Addendum No. 1

**ADDED TO THE PLANS AND SPECIFICATIONS FOR**  
**ALTARA ELEMENTARY SCHOOL REMODEL**

CANYON SCHOOL DISTRICT  
ALTARA ELEMENTARY REMODEL  
IN SANDY, UTAH

### Electrical Addendum #1

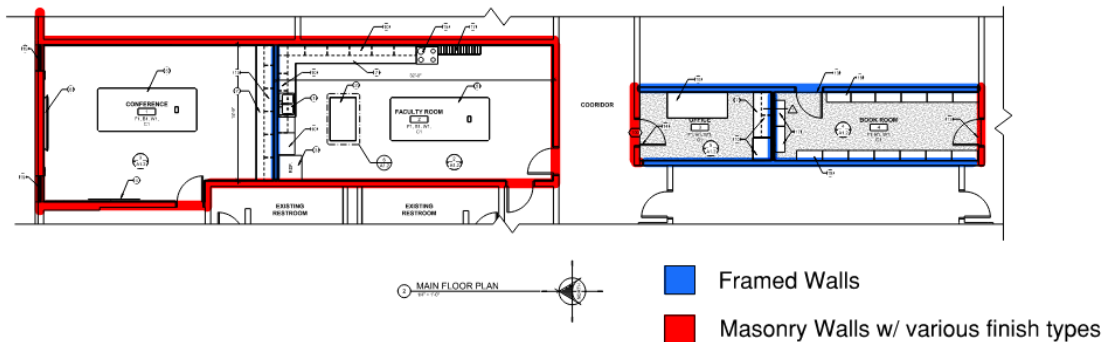
**ITEM 3.** The following image defines which existing walls are framed and which are masonry.
